LOT GRADING REVIEW

LECCO RIDGE DEVELOPMENTS INC.

PROJ. No. 16-12 MUNICIPAL ADDRESS  
LOT No. 110

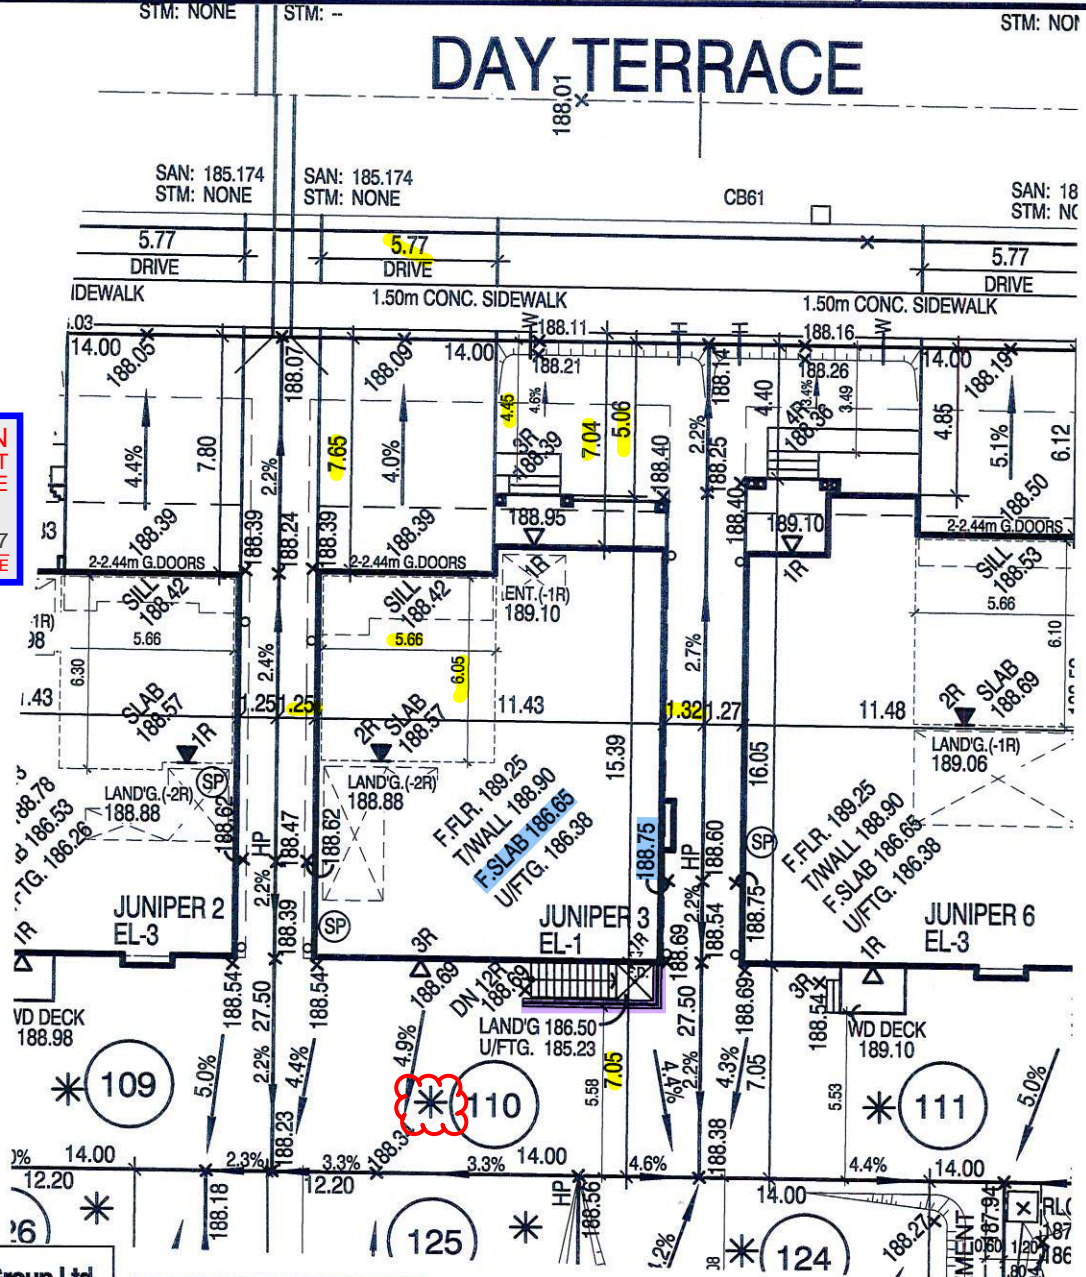
45 Min FRR

45 Min FRR w/NC Cladding

Guard/Handrail as per 9.8.

2.1 m Backfill height as per 9.15.

Siting to be read in conjunction with reviewed main model drawings

SUMP PUMP TO DISCHARGE TO REAR SPLASH PAD.

45 MINUTE RATED WALL WITH SIDE YARD < 1.2m
